HISTORIC PRESERVATION BOARD MEETING CITY OF ST. PETE BEACH

Thursday, October 7, 2021
3:30 PM

5. Action Items
 - a. **Design Review Case No. 21060: 2814 Pass-a-Grille Way**
A design review for a new single-family residence at the subject vacant property proposed to be built to the 'House-Medium' building type of LDC Sec. 20.15.

**DEPARTMENT OF COMMUNITY DEVELOPMENT
PLANNING & ZONING
STAFF FINDINGS REPORT
TO THE
HISTORIC PRESERVATION BOARD**

1
A2.01
SITE PLAN

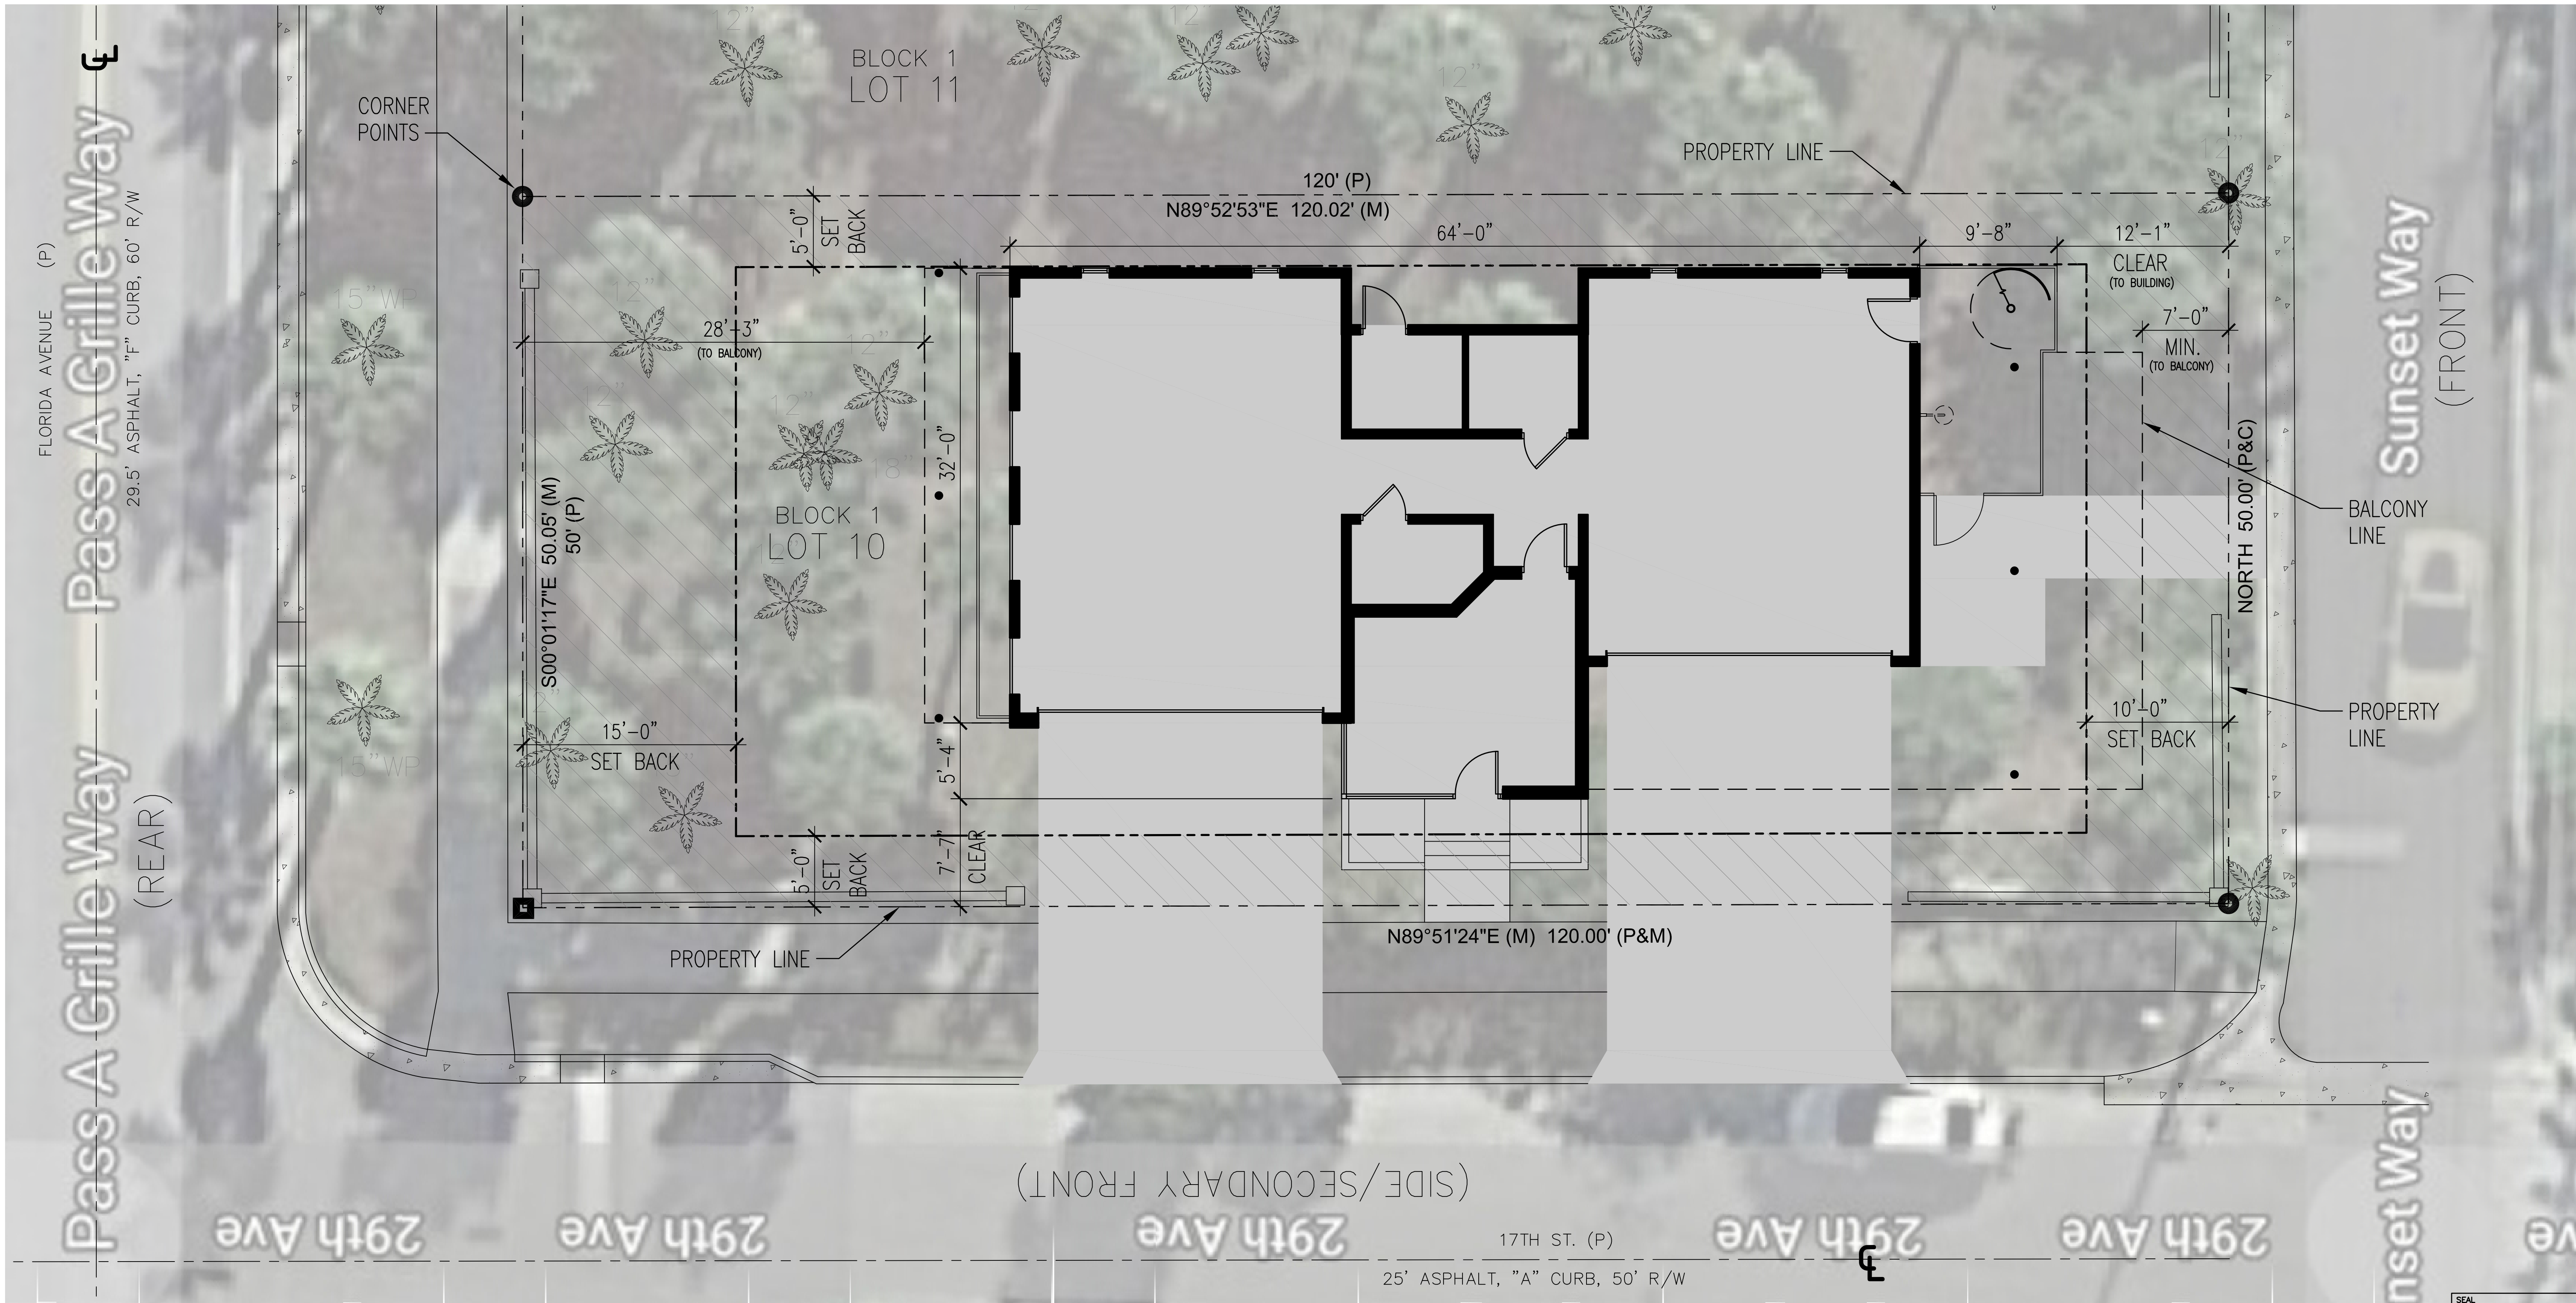
The applicant has not provided a porch or stoop that meets the structural private frontage requirements of the building types, and will therefore be required to provide "Common Yard" landscaping including a continuous hedge, wall or fence, shrubs, and one canopy tree. This requirement shall be in addition to any landscaping required for elevated buildings in the Pass-a-Grille Overlay District.

An overlay of the plan with an aerial of the block suggests that the building is relatively oriented with most homes on the western side of Pass-a-Grille Way, with the home set toward the Sunset Way rear of the lot away from the Pass-a-Grille Way frontage.

- 2) A porch, stoop or common yard private frontage that meets the requirements of LDC Sec. 20.15 shall be required to be identified on building plans.

1 NORTH ELEVATION - 29TH AVE
A5.01

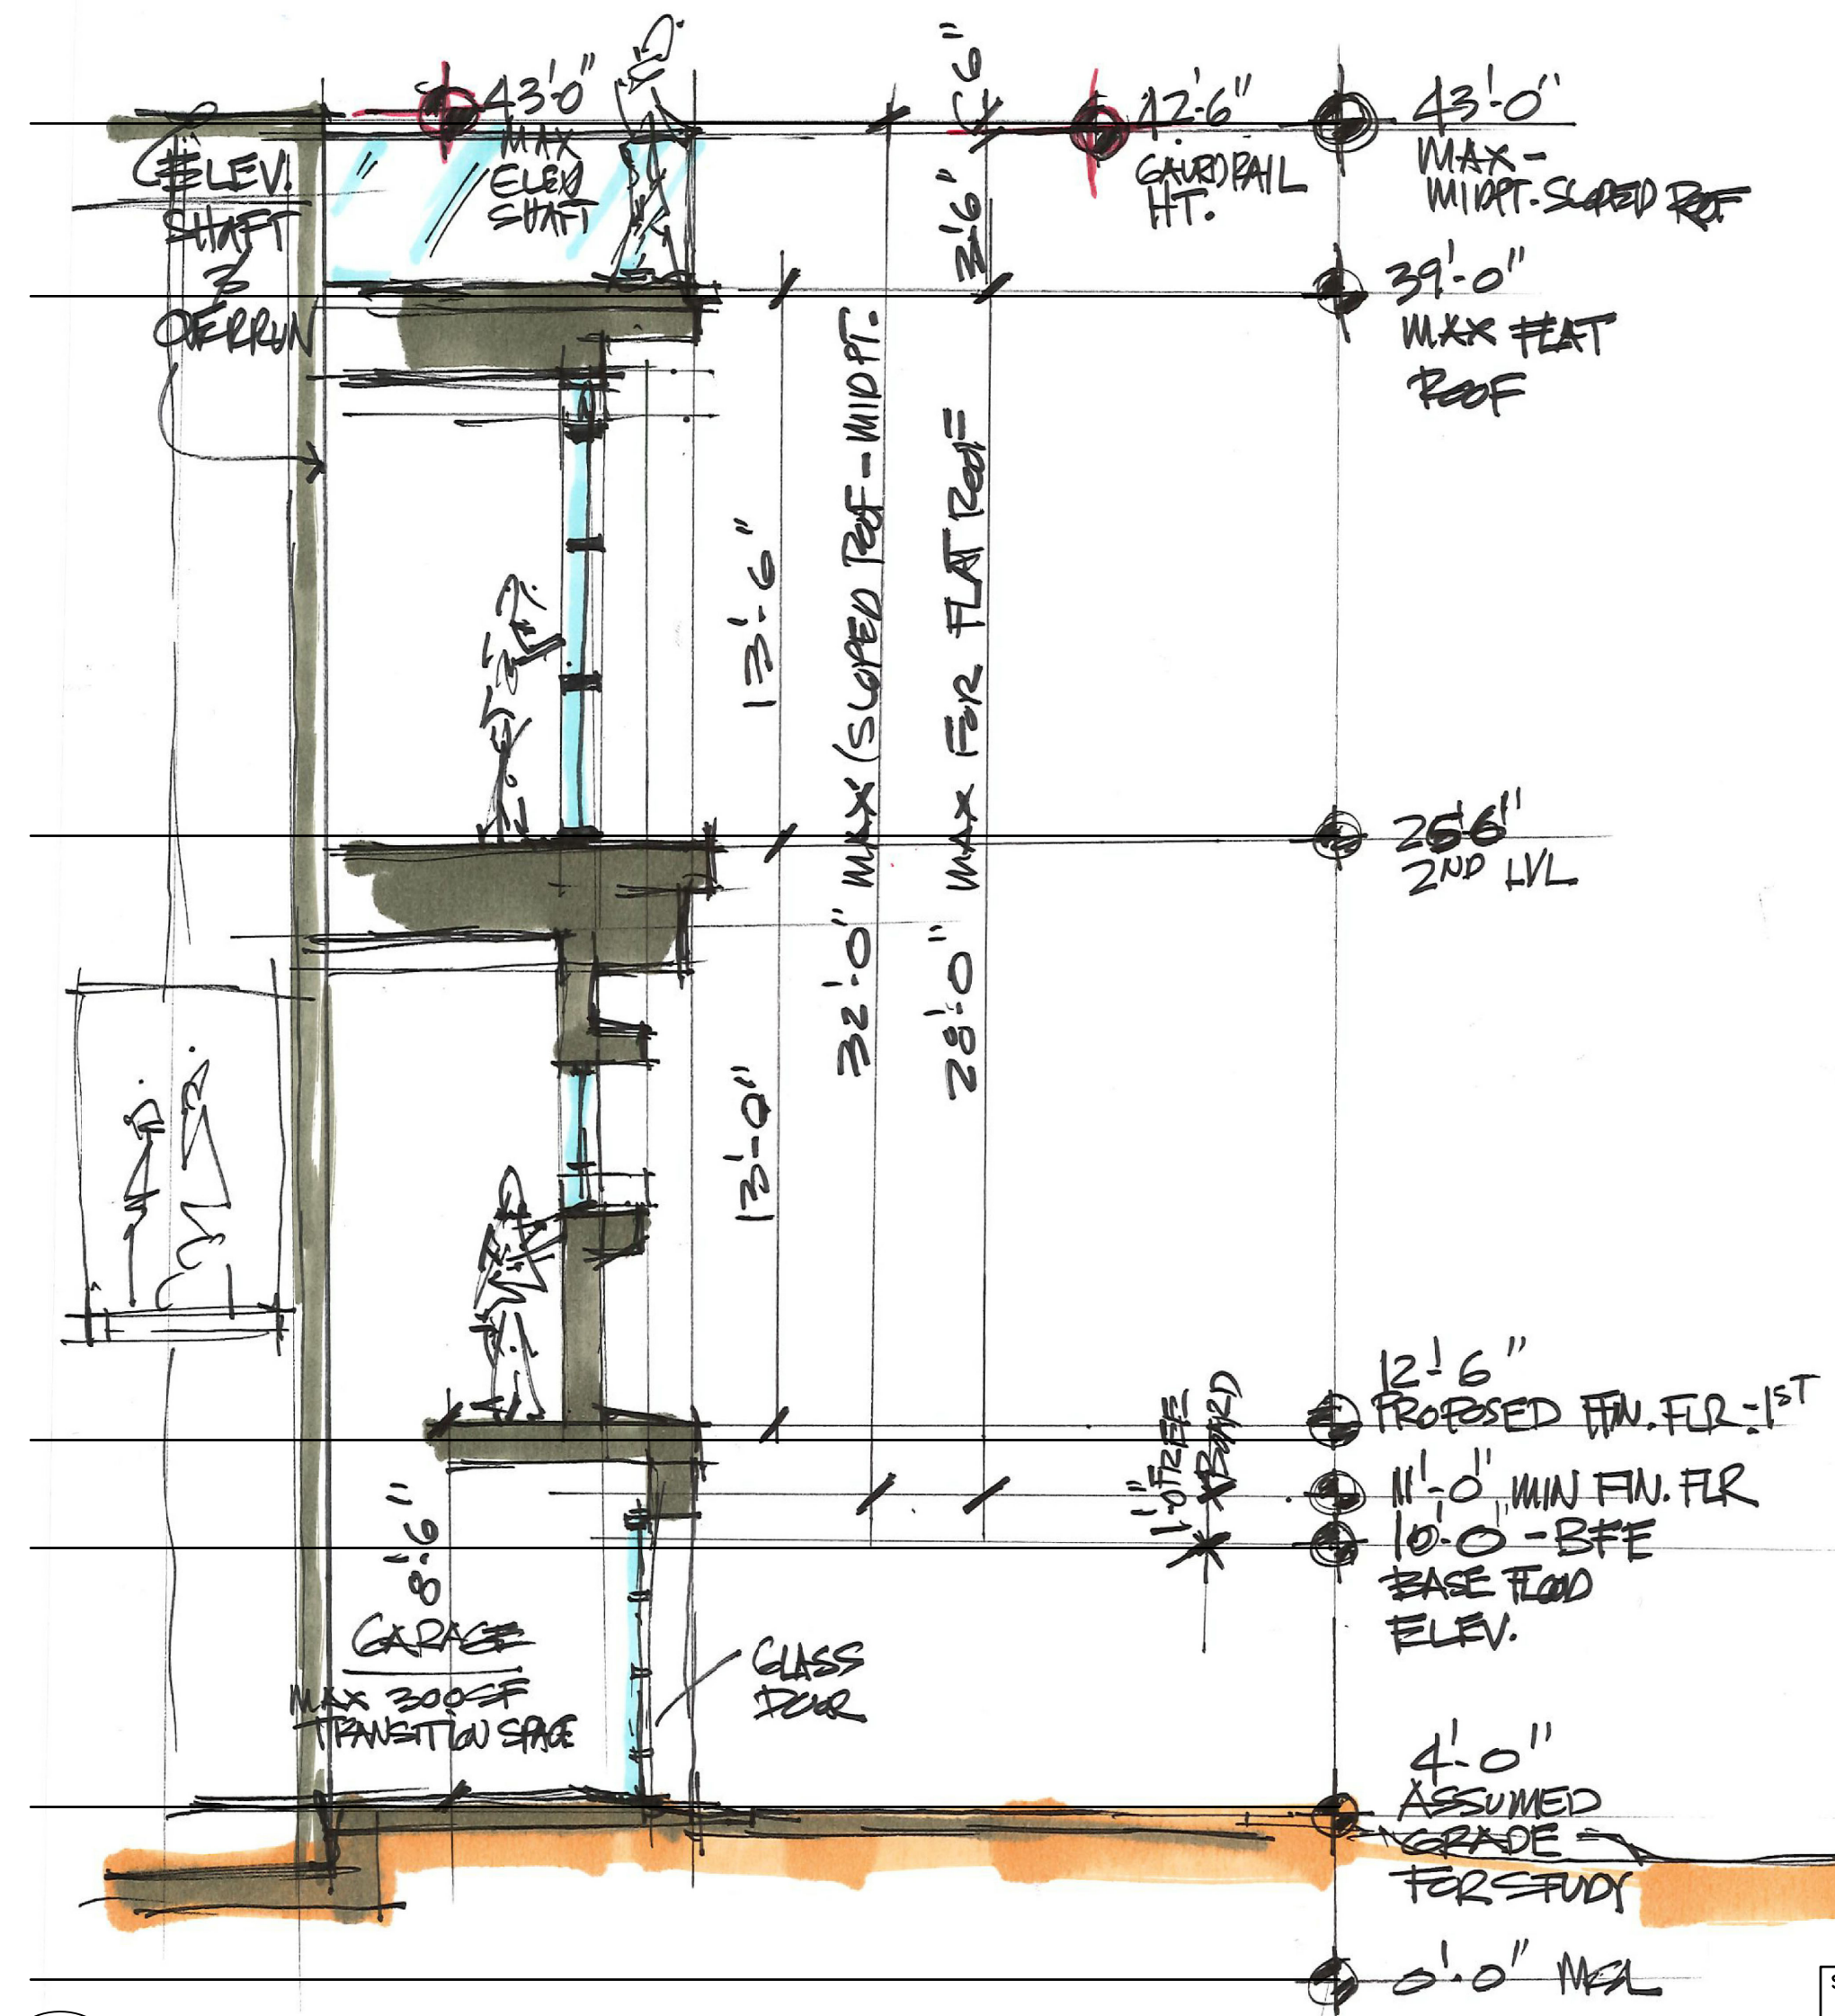
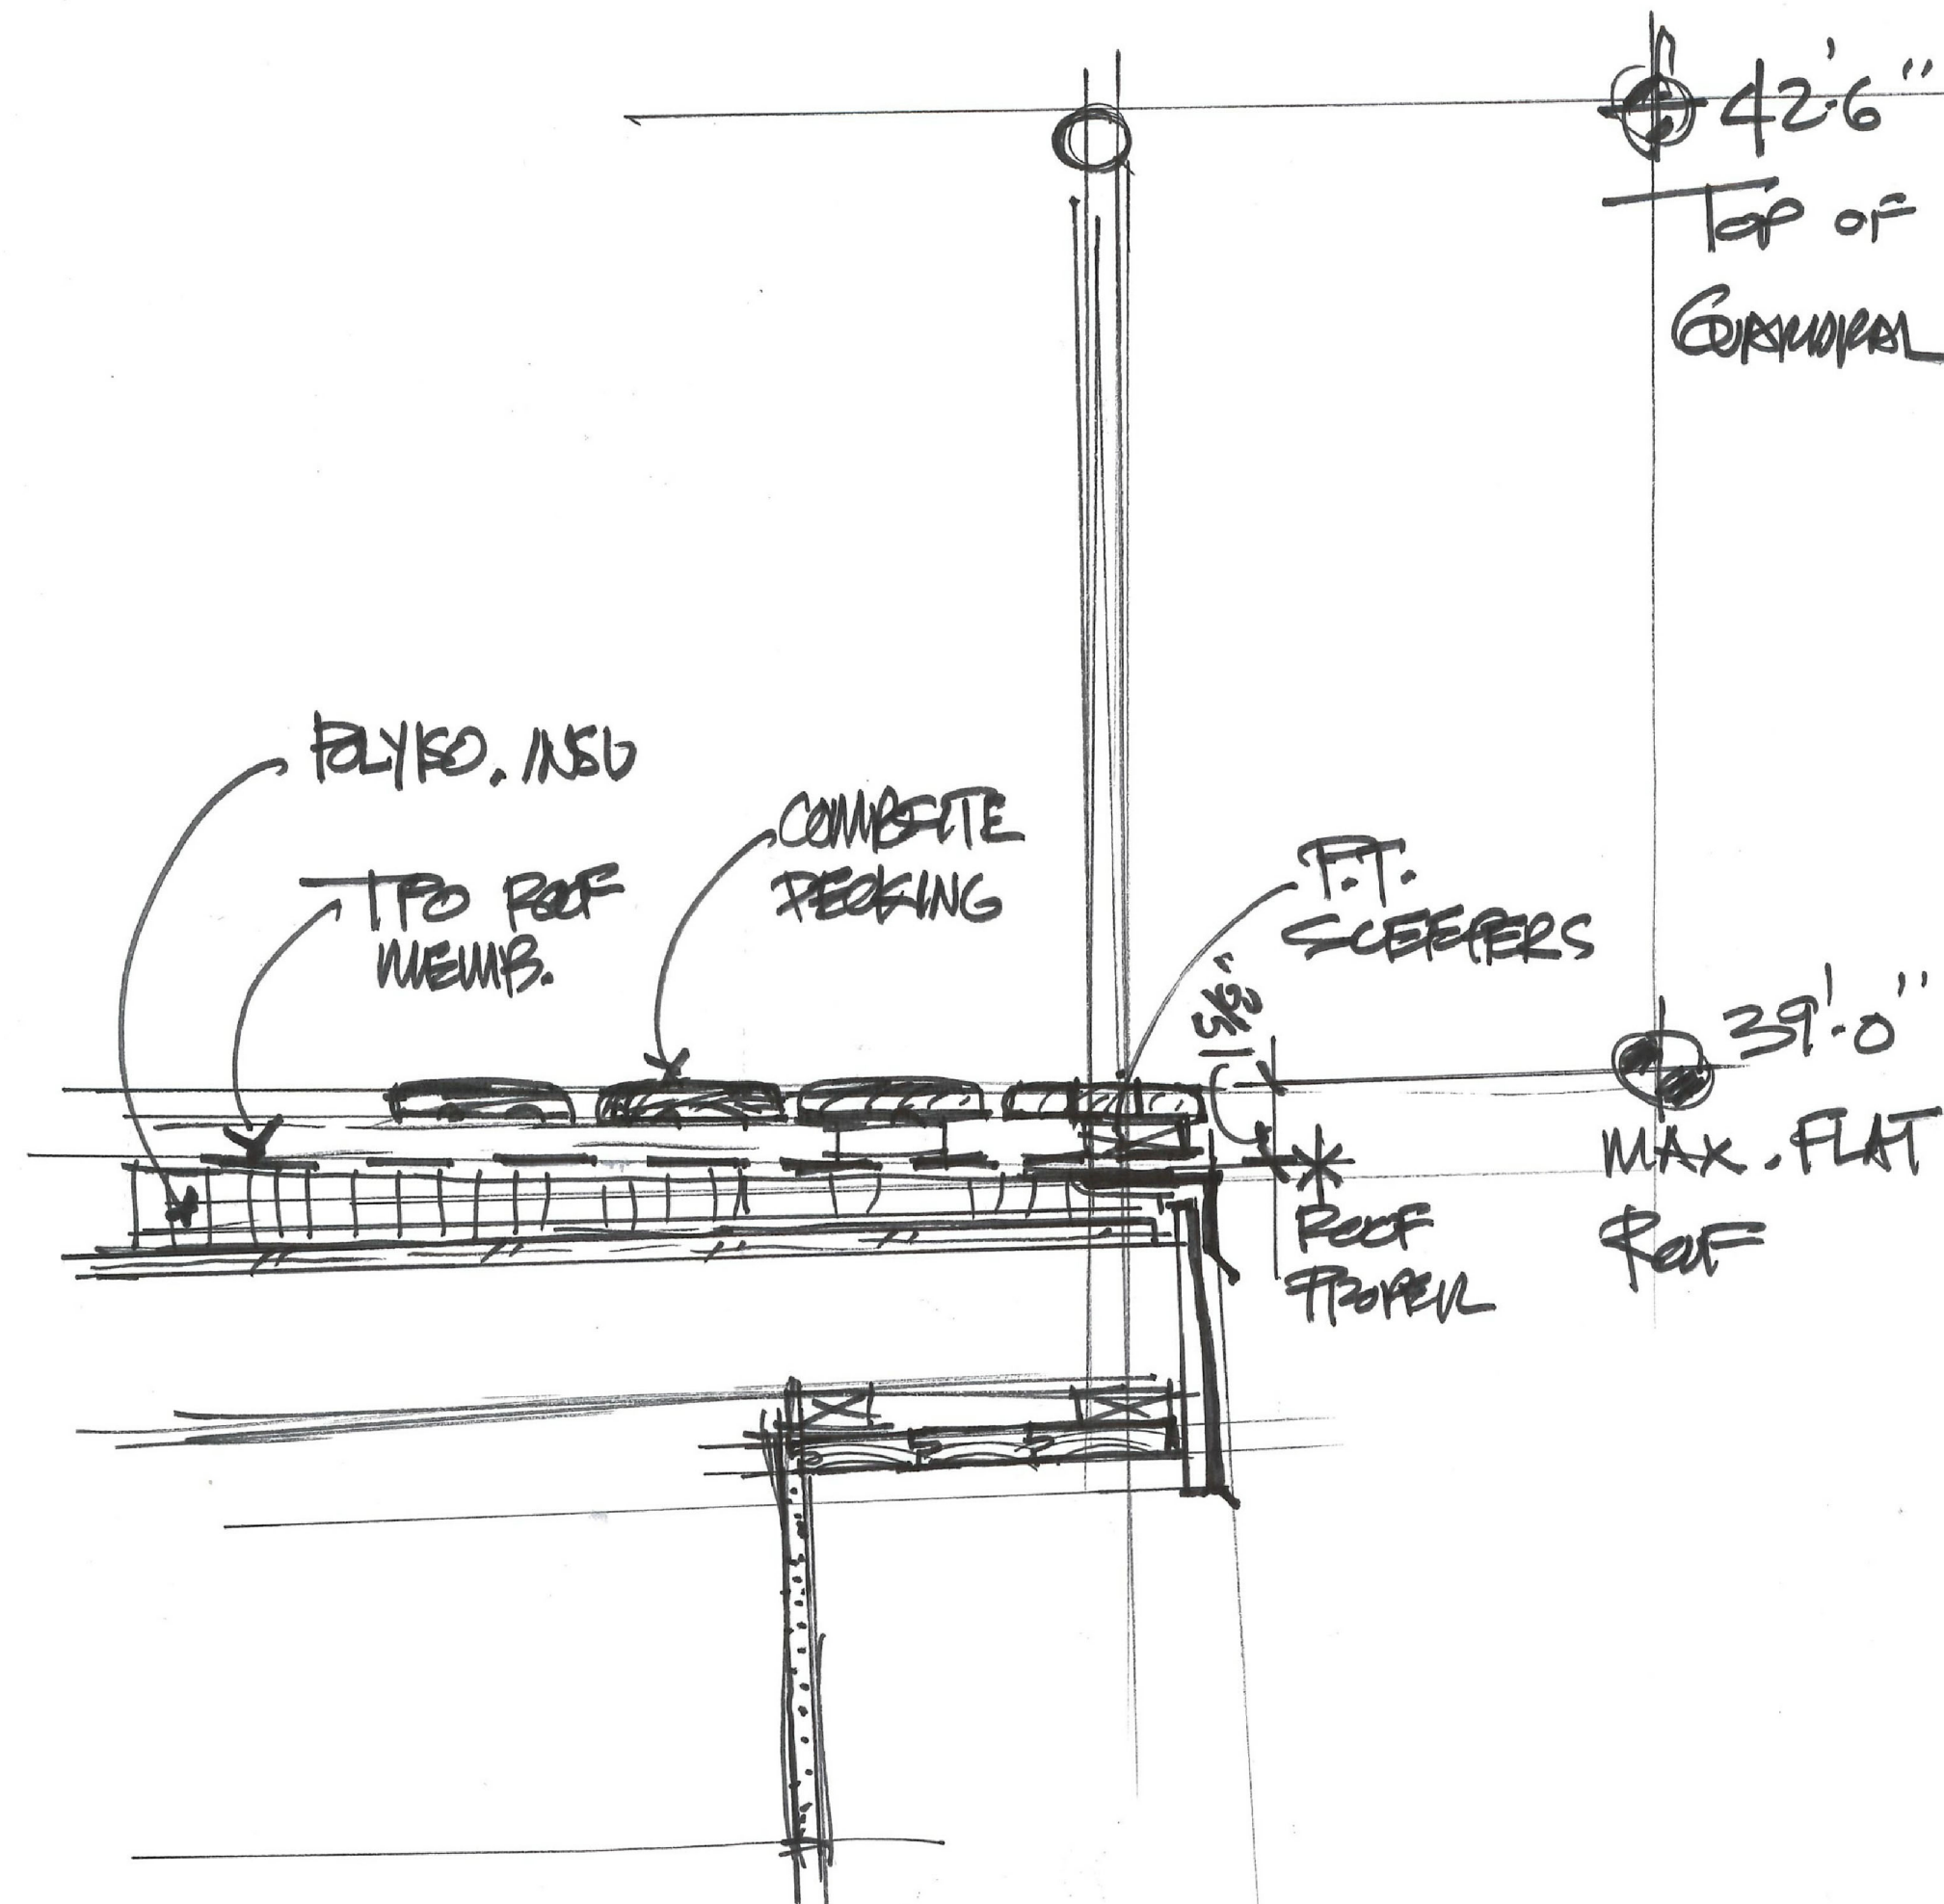
Sliding glass doors on the western and eastern sides of the building on both the second and third levels, as well as rectangular windows on the northern and eastern sides, provide voids in the façade. At the northern secondary frontage, a small glass stairwell atrium provides further breaks in the building massing.

While there are distinct elements at the ground level that provide minor additional massing to the bottom of the building, such as projecting wood composite paneling on the eastern side, Staff do not immediately recognize this criteria in the design. A certified architect shall be required to notate this element on the façade plans when submitted for building permitting.
